Plan view of the landscape plan and public use areas associated with the proposed development

Plan view of the proposed public use areas that include the streetscape improvements and the plaza on the eastern boundary

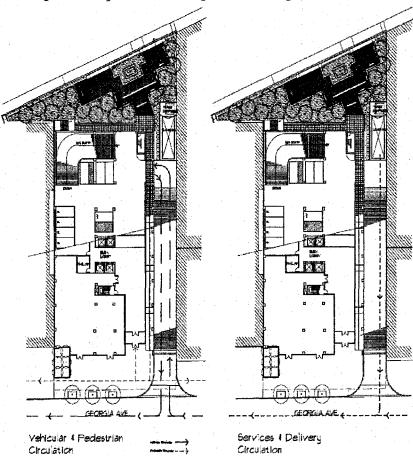
An 8-foot-wide pedestrian walkway under the canopy of the proposed building connects the public use space on the eastern edge of the property, adjacent to the driveway for the public parking garage. The existing masonry wall will be removed by the Applicant to ensure pedestrian access to the parking garage and for a north and south connection along the driveway.

The project plan proposes an additional 16 feet of dedication along the Georgia Avenue frontage for a total right-of-way of 126 feet. The Applicant will need to enter into an agreement with the Parking Lot District for the removal of the masonry wall at the eastern edge of the property.
